# UNITED STATES PATENT AND TRADEMARK OFFICE

APPLICATION NO.	FILING DATE	FIRST NAMED INVENTOR	ATTORNEY DOCKET NO.	CONFIRMATION NO.
10/779,751	02/18/2004	Jin-Ho Park	1349.1292	2039
21171	7590	08/23/2007		
STAAS & HALSEY LLP SUITE 700 1201 NEW YORK AVENUE, N.W. WASHINGTON, DC 20005			EXAMINER UHLLENHAKKE, JASON S	
			ART UNIT 2853	PAPER NUMBER
			MAIL DATE 08/23/2007	DELIVERY MODE PAPER

# Office Action Summary

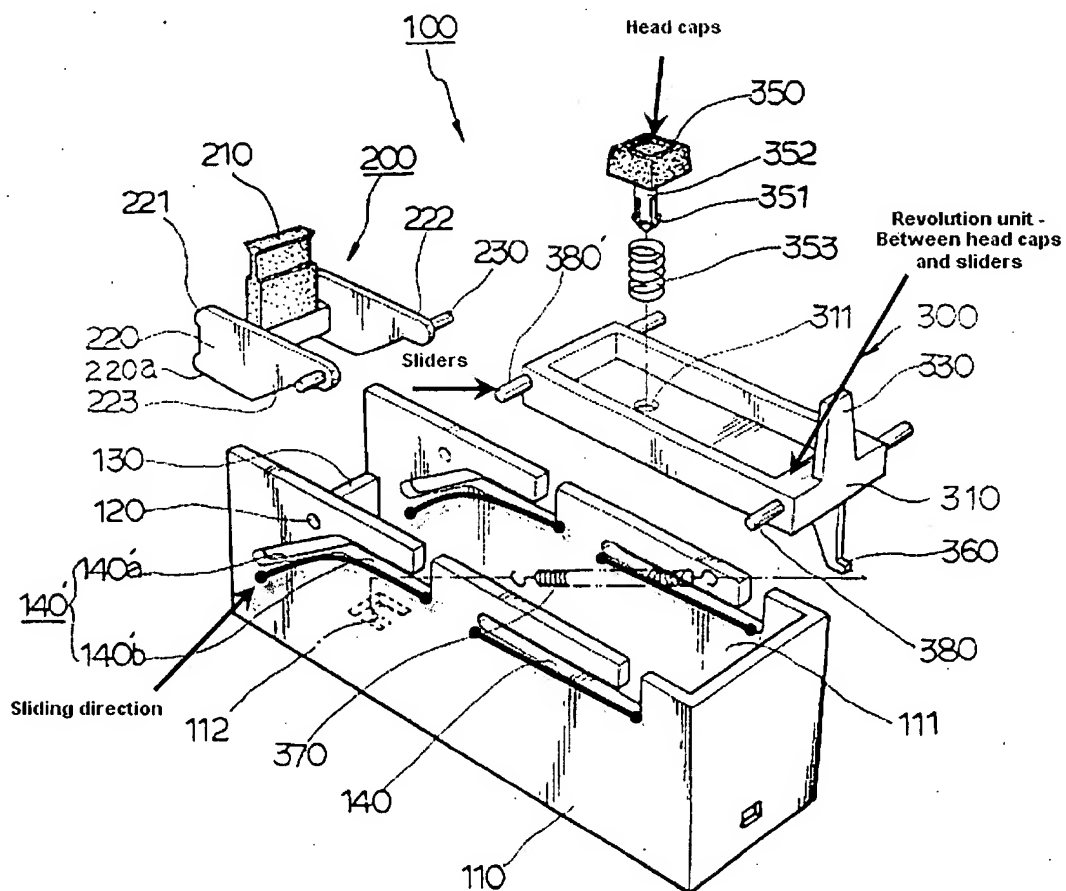
Regarding claims 1 and 11, applicant argues that Lee does not disclose the invention as recited in claim 1 and 11. However, the structure of the slider and revolution unit are not clearly defined in claims 1 and 11, so Lee meets all of the claimed limitations of claims 1 and 11. Lee discloses guide pins (380), which clearly slide within the guide slots of the housing in order to revolve the revolution unit (moving member 310), in association with the guide pins (slider 380), to cap and seal the nozzle. The carriage (2) moves along the guide shaft to the service area and pushes the slider

(380) and revolution unit (moving member 310). The carriage (slider movement unit) slides the slider (380) as disclosed in claims 1 and 11.
